DANE COUNTY DEPT. OF PUBLIC WORKS, HIGHWAY & TRANSPORTATION

ADDENDUM

RFB NO. 320038 - ADDENDUM NO. 02

DANE COUNTY SHERIFF'S SE PRECINCT REMODEL AND ADDITION

S302

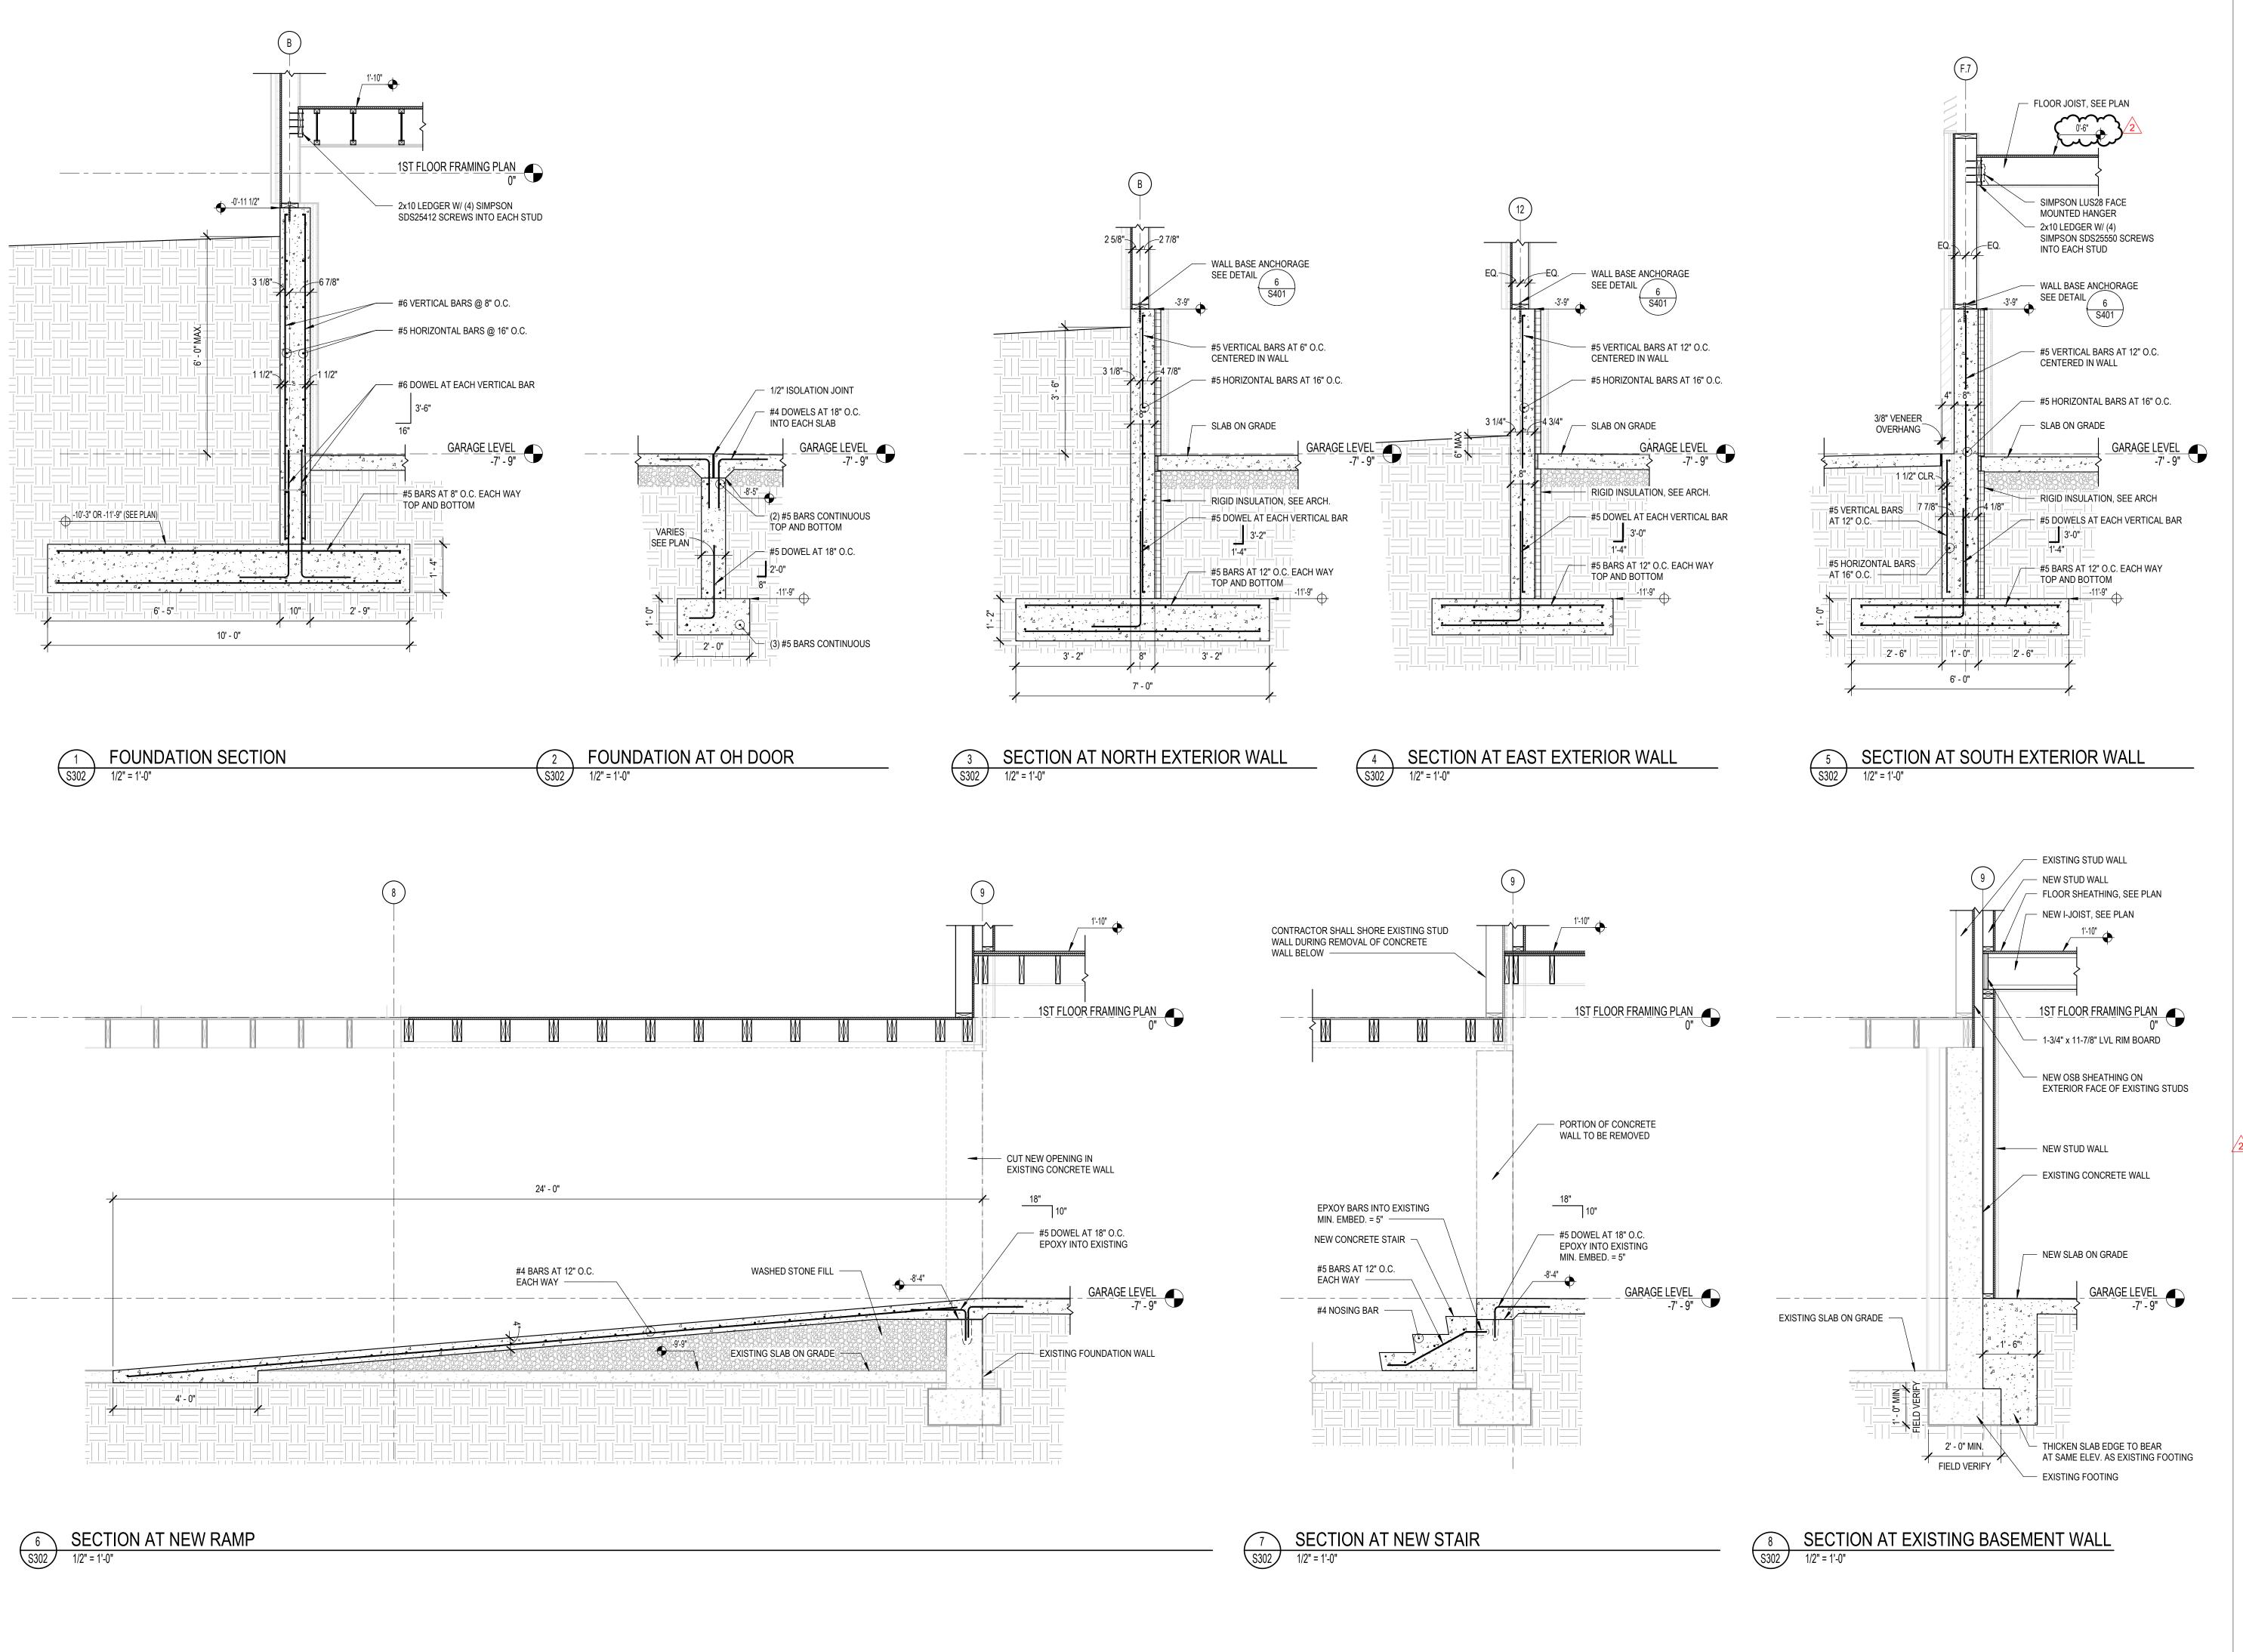
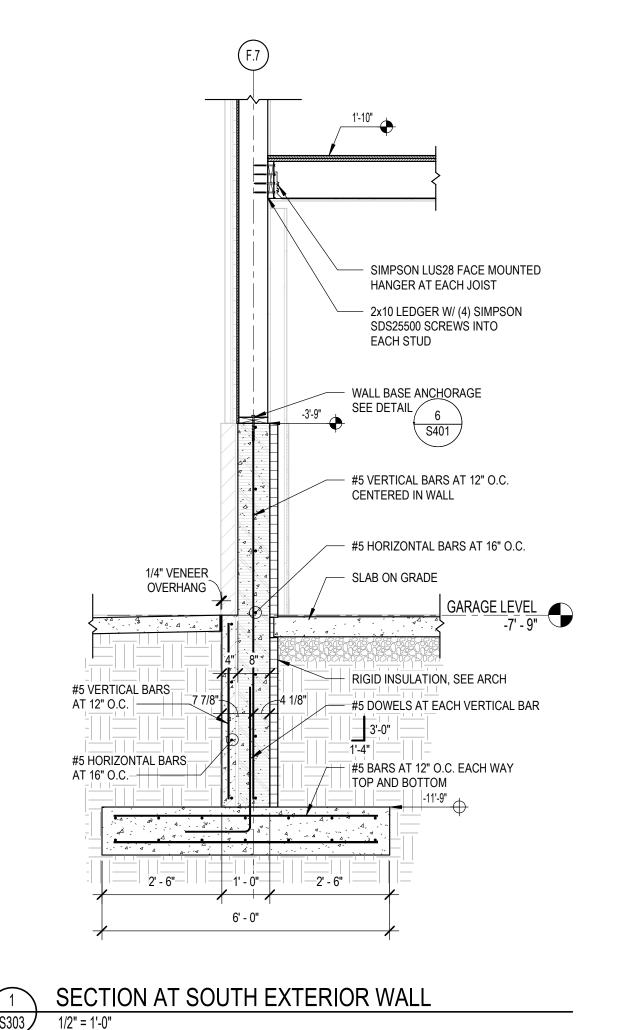
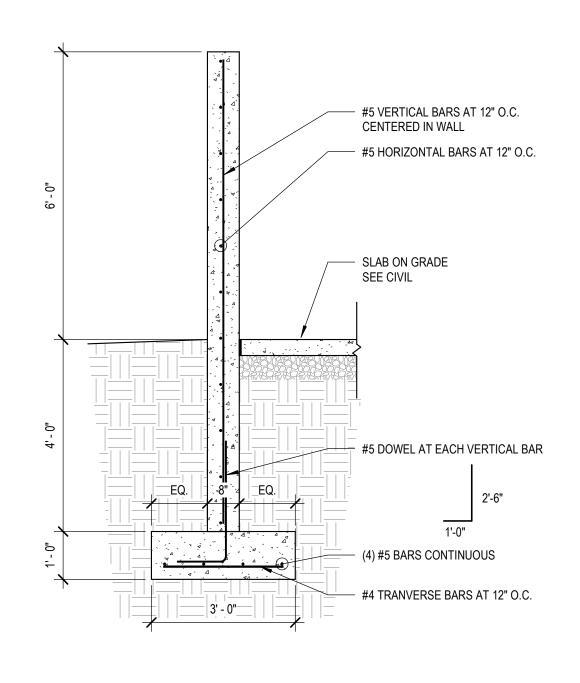
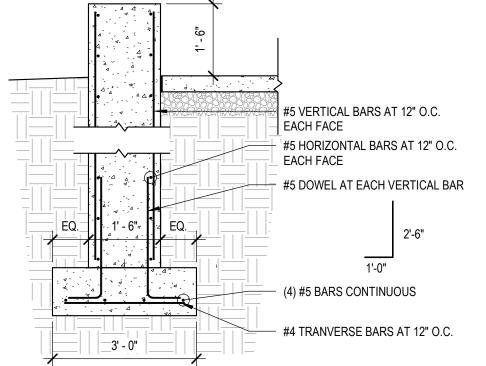
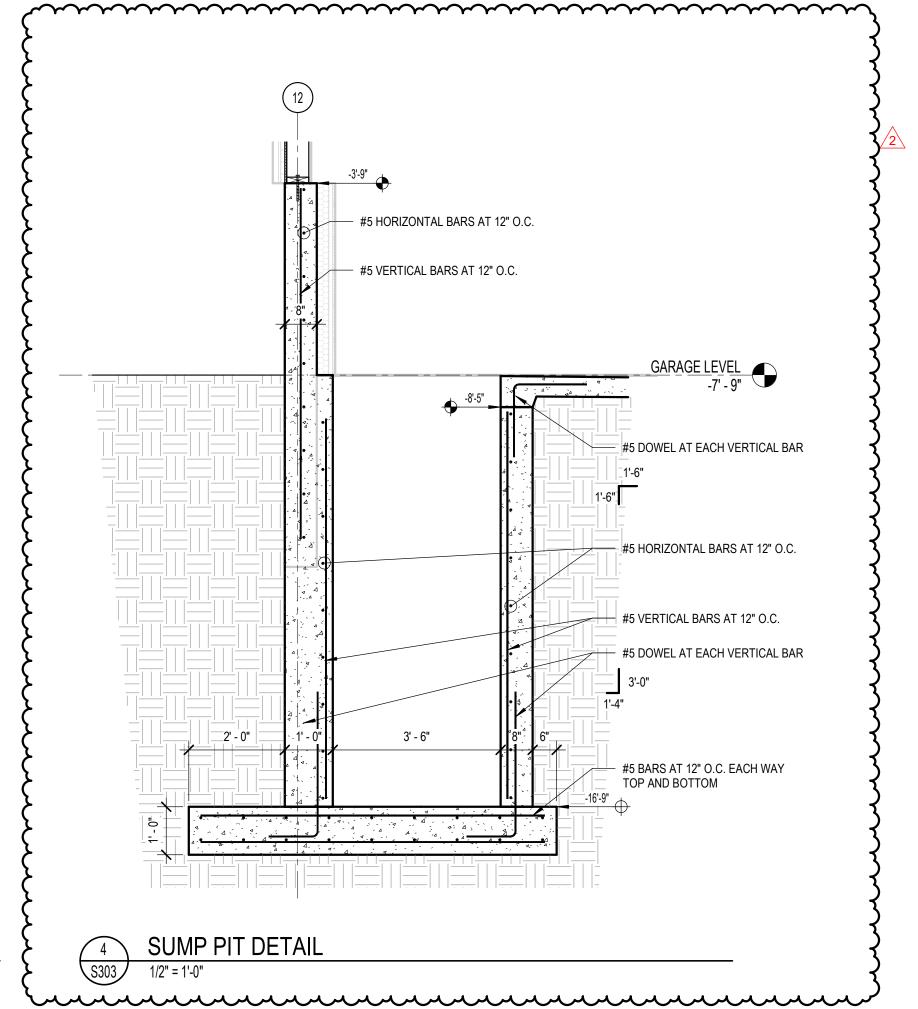
38. Sheet S302

Modify current Sheet S302 Foundation Details as indicated and issued with this Addendum.

a. Detail 5/S302- Revise top of sheathing elevation at Storage Room.
